Cobb County Community Development Agency

Case # Z- 21 Public Hearing Dates: PC: 04-03-18 BOC: 04-17-18

FINAL ZONING STAFF RECOMMENDATION: (Zoning staff member: Jason Campbell)

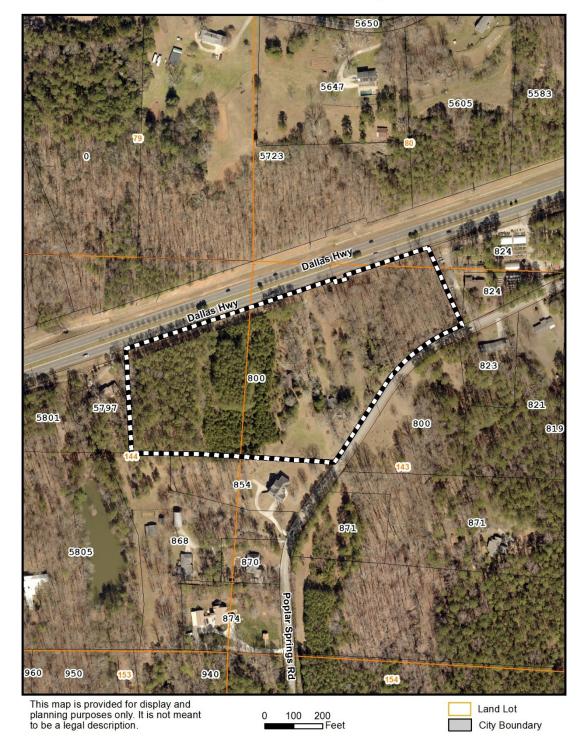
Additional comments:

- 1.) The rear setback for lots 1-8 & 9 is shown as 35', but should be 40'. Staff believes the 40' rear setback for these lots is obtainable, and a variance should not be granted from the code.
- 2.) Fencing that is compatible with the architecture/landscaping/design of development, shall be erected just inside dedicated open space that is contiguous to proposed lots. Fencing should be installed using techniques that provide as minimal disturbance to the open space as possible.
- 3.) A conservation easement shall be recorded within the mandatory subdivision covenants and with Cobb Superior Court, thereby protecting the open space from development in perpetuity as owned by the mandatory homeowner's association. A conservation easement application shall be submitted to the Planning Division prior to final plat approval.
